ADDENDUM NO. 1
March 29, 2022

DSA Application No.: 04-120740

EL CAMINO HIGH SCHOOL TRUAX EXTERIOR IMPROVEMENTS
ROOFING/HVAC/ACCESS LADDER
Oceanside Unified School District

Prepared by: LEAF Engineers
8163 Rochester Avenue, Suite 100
Rancho Cucamonga, CA 91730

PRE HVAC INSTALL DETAIL AD-01

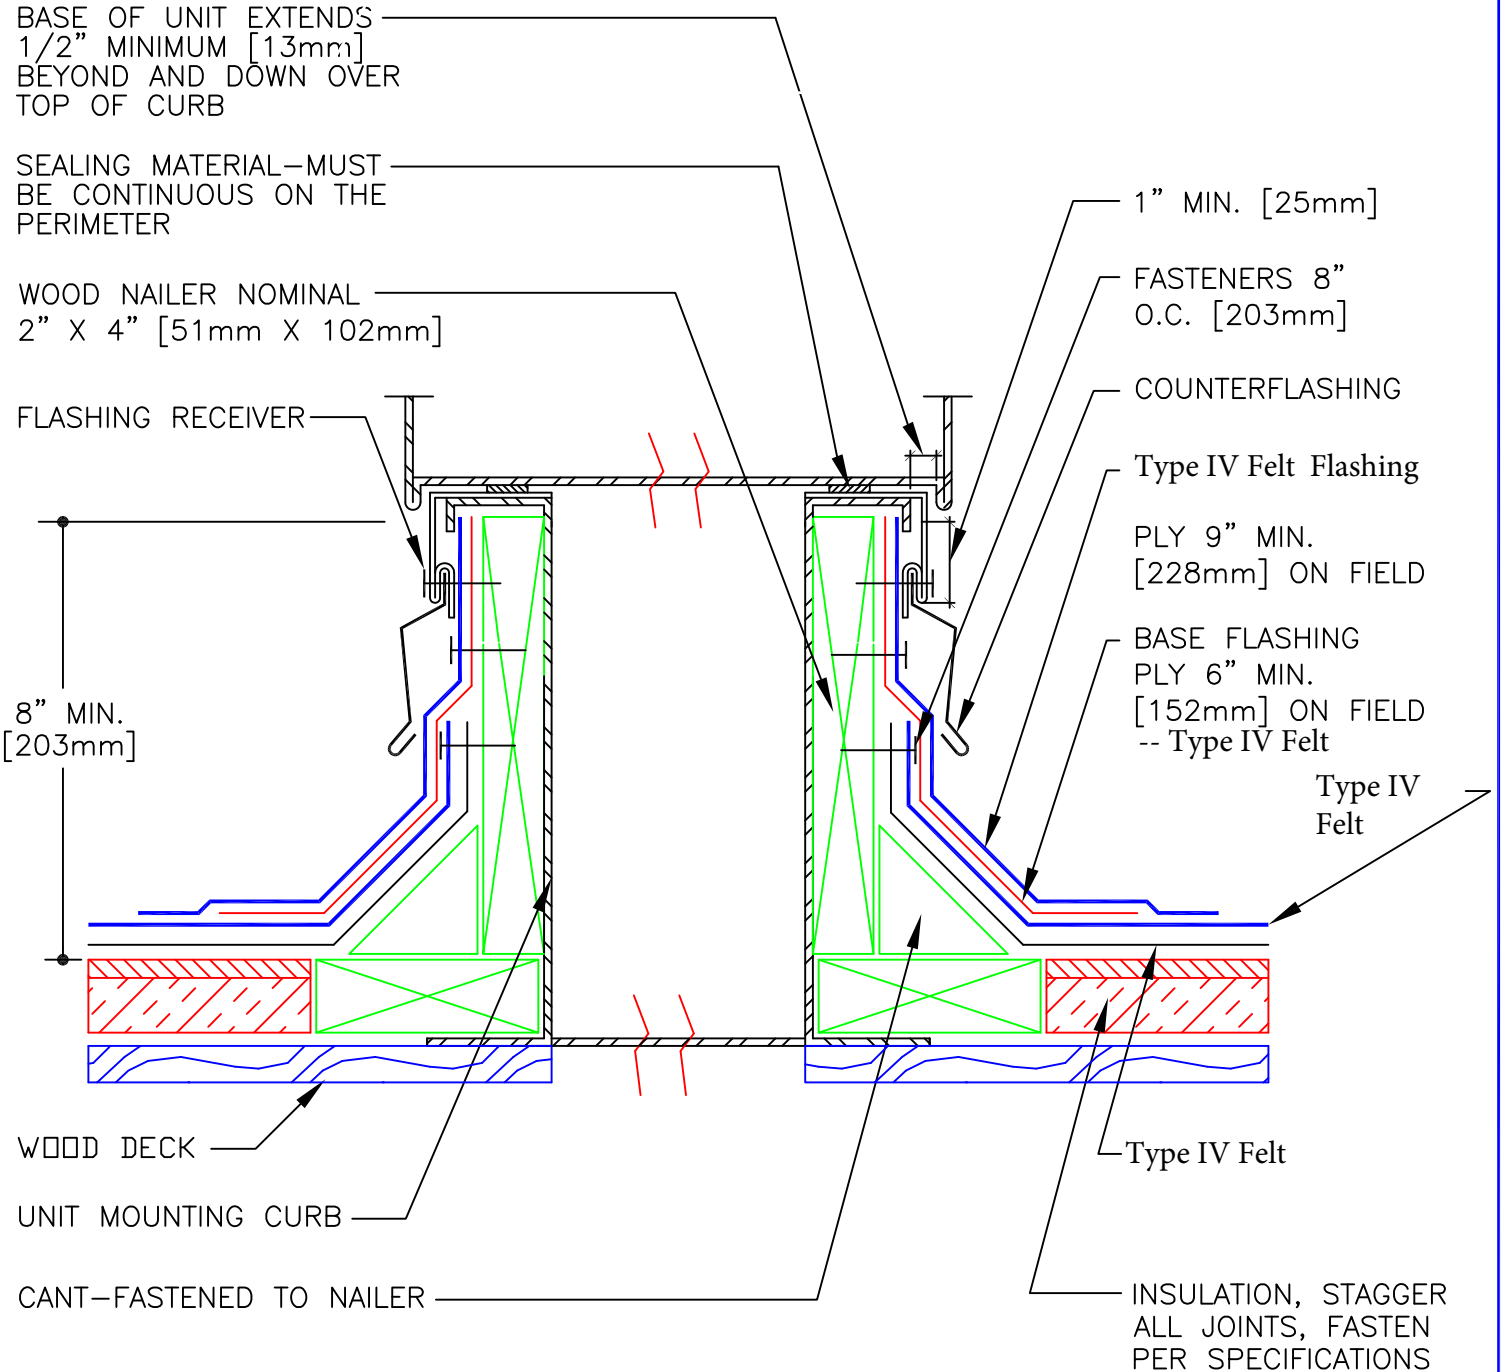
Item No. 1.09: Question: During course of job walk, PM stated that District anticipates multiple mobilizations. Roofing must be done over the summer months, however, current lead time estimate for HVAC units is 22-25 weeks which would require remobilization around October 2022. Please advise if it would be acceptable to demo and re-roof the two “upper roofs” over the summer break and leave the “lowest roof” to be completed when remobilize for HVAC install. If not, please provide temporary detail for terminating new roof adjacent to existing curbs tying into existing roofing until HVAC units can be replaced.
Answer: This is a means/methods question. Attached are details for temporary install of roofing pre HVAC unit install and post HVAC install for final roof installation. Details AD-01 and AD-02.

17 | **NEW NOMENCLATURE**
 NOT TO SCALE

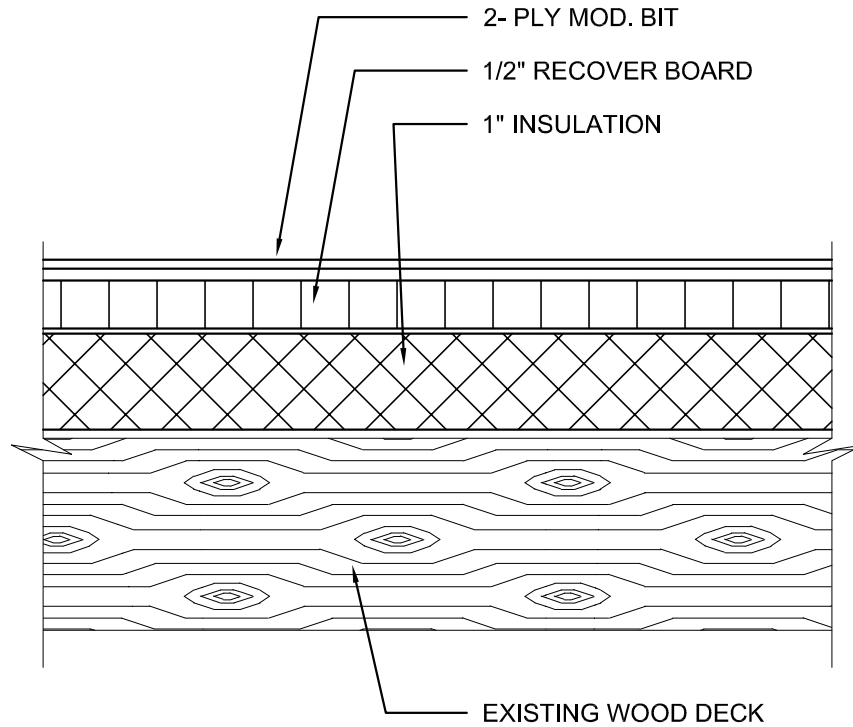
A) Detail 17 on sheet A.10 has been revised, see attached detail AD-03.
